## **HICKMAN FAMILY ESTATES SUBDIVISION**

APPLICATION NUMBER 5 DATE September 17, 2015

REQUEST Subdivision

# DETAIL SITE PLAN

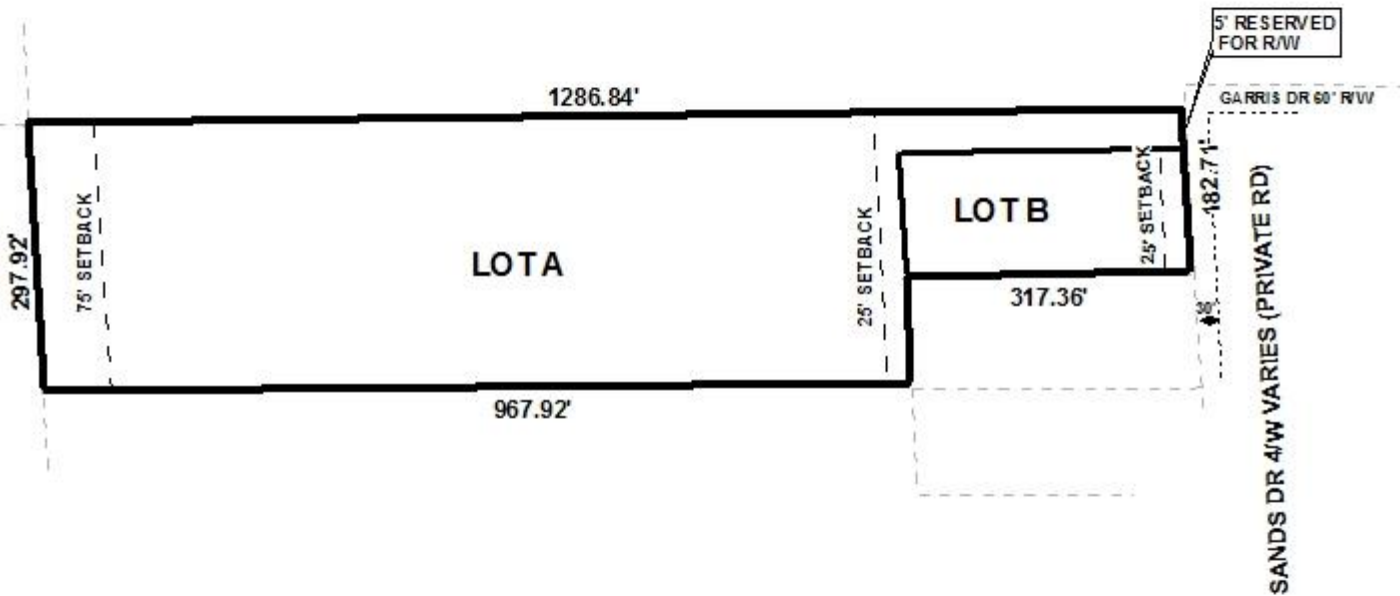
Ingress/egress for the proposed Lot A is planned via the pole portion of the lot which measures 45'± wide by 317'± long. Due to the limited frontage (45'±) provided, if approved, future subdivision of the proposed Lot A should be prohibited until additional frontage along a public or private street is provided. This note should appear on the Final Plat, if approved.

In accordance with the Subdivision Regulations, both proposed lots exceed the minimum lot size requirements and the 25' minimum building setback line is depicted on the preliminary plat and should be retained on the Final Plat, if approved.

The proposed subdivision has frontage along Sands Drive, a minor street without curb-and-gutter. As dedication, sufficient to provide 30' as measured from centerline, was a condition of approval from the previous request, the current right-of-way is sufficient and, as such, no further dedication is required. The Final Plat should be revised to depict the minimum existing right-of-way width.

The Major Street Plan component of the Comprehensive Plan illustrates a proposed major street (Eliza Jordan Road) which is planned to run along the western boundary of the proposed Lot A. The proposed right-of-way with is 100', which requires 50' on either side of the centerline. Per the previous 2014 approval and, in conjunction with other subdivisions approved by the Commission which front a portion of the proposed route, instead of requiring dedication from the proposed centerline, the Commission has instead required a 75' setback, which included 50' measured from centerline for the proposed right-of-way and an additional 25' for a front-yard setback. This request should be considered in a similar manner as the previous approval. As such, a 75' setback is depicted on the preliminary plat and, as there are no known immediate plans for the street's construction, the setback should be retained on the Final Plat, if approved.

As the proposed Major Street is planned to run along the western lot line of the proposed Lot A, access management may be a concern since the proposed lot would be considered "Double Frontage Lot" with the construction of the proposed Major Street. Section V.D.8. of the Subdivision Regulations references double frontage lots and prohibits access via the proposed Major Street. Therefore, the proposed Lot A should be denied access to the proposed major street and the Final Plat should be in compliance with Section V.D.8. of the Subdivision Regulations, if approved. It should be noted that if the applicant desires access via the proposed Major Street once it is constructed, the applicant may present this site to the Planning Commission for consideration at that time.

Both proposed lots should be limited to 1 curb-cut each, with the size, design and location to be approved by Mobile County Engineering and conform to AASHTO standards.

- 1) Submission of 7 probated copies of the Final Recorded Plat of Hickman's Way Subdivision, prior to the signing of the Final Plat;
- 2) Revision of the Final Plat to illustrate the minimum existing right-of-way;
- 3) Retention of the lot size information and all setbacks on the Final Plat;
- 4) Placement of a note on the Final Plat stating that no future subdivision of Lot A will be allowed until additional frontage along a paved public street is provided;
- 5) Placement of a note on the Final Plat stating that Lot A is denied access to Eliza Jordan Road, a proposed Major street;

- 6) Placement of a note on the Final Plat stating that both lots are limited to one (1) curb-cut each to Sands Drive, with the size, design and location to be approved by Mobile County Engineering and conform to AASHTO standards;

- 10) Compliance with Section V.D.8. of the Subdivision Regulations and placement of a note on the Final Plat.
